UNITED STATES
NUCLEAR REGULATORY COMMISSION

SUBJECT: SUMMARY OF MEETING WITH THE NUCLEAR ENERGY INSTITUTE (NEI) TO DISCUSS STAFF'S REQUEST FOR ADDITIONAL INFORMATION (RAI) ON ENVIRONMENTAL ASSISTED FATIGUE

**REQUEST FOR ADDITIONAL INFORMATION
FOR PROPOSED INTERIM STAFF GUIDANCE (ISG)
FOR FATIGUE ENVIRONMENTAL EFFECTS**

Discussion of Response to RAI on ISG-11

Original LAS Data (MRP-49) Plotted vs. MRP-74 Modified Equations

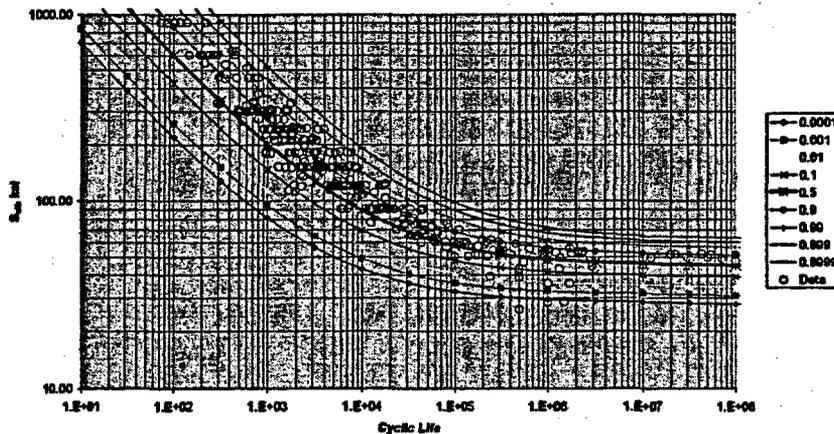
- *The revised probabilistic fatigue curves do not appear consistent with the data for carbon and low alloy steels. For example, compare probabilistic curves developed using the EPRI assumption for the standard deviation of the endurance limit with the data presented in Figure 14 of Attachment 1 of the submittal.*

- Most of data are above the mean curve
- Only a few points below the mean curve
- Detailed review of data shows low points resulted from high R-ratio testing
- Correction for mean stress effects shows that observed low points are within scatter band for remainder of data
- Therefore, the standard deviation chosen to represent the data is conservative

Mean Stress Effects

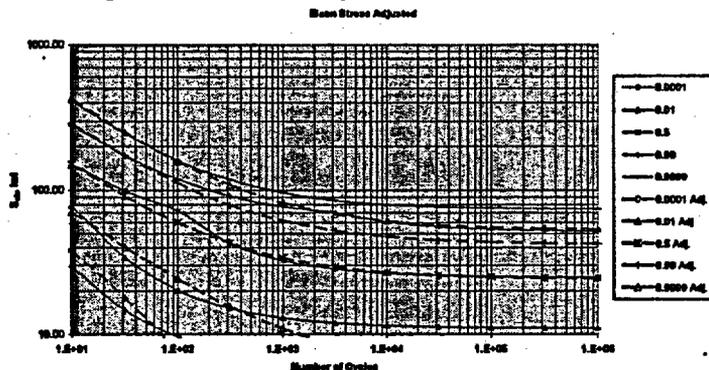
- The strain thresholds are discussed on page 26 of NUREG/CR-6717. NUREG/CR-6717 indicates that, after mean stress effects are taken into account, a threshold strain amplitude of 0.07% provides a 90% confidence level for both carbon and low alloy steels. As discussed previously, the threshold strain is approximately 20% higher than the endurance limit of the steel. Consequently, the 10 percent probabilistic fatigue curve should approach a strain amplitude of approximately 0.06% at $10E6$ cycles. The 10 percent probability curve shown in Figure 3-11 of the EPRI report is not consistent with a strain of 0.06%. Discuss this discrepancy between Figure 3-11 of the EPRI report and the data assessment contained in NUREG/CR-6717.

- The EPRI report, page 3-11, provides a procedure to account for mean stress effects. Show how this procedure was implemented in the evaluations presented in Chapter 4 of the report. Discuss the consistency of the mean stress adjustment used in the Chapter 4 evaluations with the mean stress adjustment discussed in NUREG/CR-6717.

- Comparison of effective fatigue curves using NUREG/CR-6635 data fits and modified fatigue curves for carbon steel

- Environmental effects at 550°F. Solid lines are mean-stress corrected data curves and dotted lines are NUREG/CR-6335 Equation 18. Both use NUREG/CR-6335 endurance limit data scatter
- Approach used in MRP-74 is more conservative at low quantiles – correction made to modified fatigue curve not to mean

Results From the PVRC Fatigue Testing of Full Size Carbon Steel Pressure Vessels

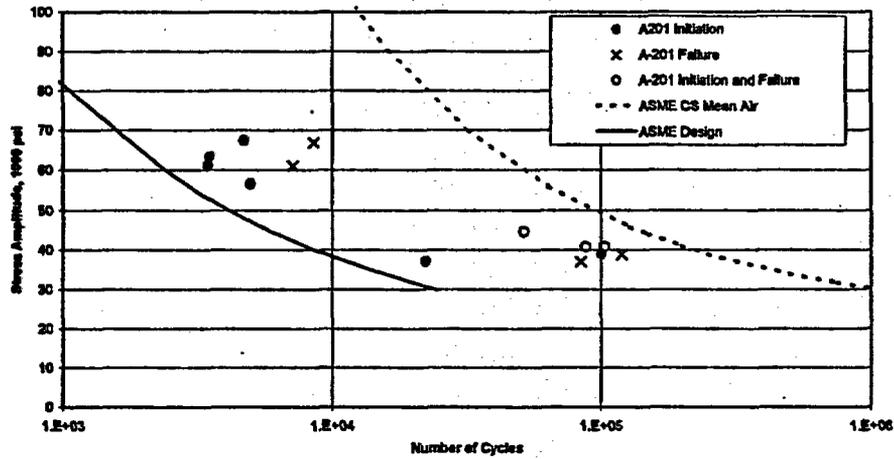
- Question
 - *The submittal references the evaluation of the component fatigue tests contained in EPRI Report MRP-49. The evaluation of the component fatigue test data is similar to the evaluation contained in EPRI Technical Report, "Guidelines for Addressing Fatigue Environmental Effects in a License Renewal Application (MRP-47)," Draft Revision G dated June 5, 2001. This report was submitted to the NRC by NEI letter dated July 31, 2001. The staff transmitted a request for additional information regarding the evaluation of the component fatigue tests by letter dated June 26, 2002. The staff has not received a response to its request for additional information. Indicate how the relevant June 26, 2002, staff comments have been addressed in the test data evaluation contained in EPRI Report MRP-49.*

- **MRP-47 RAI on Evaluation of Component Fatigue Tests**
 - *The evaluation of component tests did not include the data from the Southwest Research Institute tests on vessels that is shown on page 4 of NUREG/CR-6583. This test data does not appear to support conclusion regarding the maximum effect of size and surface finish on fatigue life. Explain why this data was omitted from the evaluation. Provide an assessment of the Southwest Research Institute using the same method used to assess the KWU tube tests and the General Electric pipe tests.*

- Appendix C of MRP-47 evaluated preliminary component-scale fatigue data with at least one surface in contact with oxygenated water at temperature
- MRP-49 included component-scale fatigue data with at least one surface in contact with oxygenated water at room temperature – the same PVRC/SWRI carbon and low-alloy steel pressure vessel fatigue data shown on page 4 of NUREG/CR-6583
- The evaluation process for these pressure vessel fatigue test data was identical to the process used to evaluate the KWU 180-degree bend fatigue tests and the General Electric pipe tests. The results for all three sets of component fatigue tests are completely consistent

- Results from the PVRC tests were reported in MRP-49 (Figures 2-35 and 2-36). While some of the crack initiation results approach the ASME Code fatigue design curve, none of the cycles to crack initiation were less than the design curve. Since the intent of the ASME Code fatigue design curves is to predict the mean line for crack initiation in actual vessels, these tests demonstrate that the margins used by the ASME in developing the design curves are conservative, even with exposure of vessel inner surfaces to oxygenated water.
- Figure 2 from NUREG/CR-6583 shows essentially the same data, but does not show the comparison between the ASME design curve and air curve, so that the reader may have difficulty determining whether the data points are located appropriately or not.
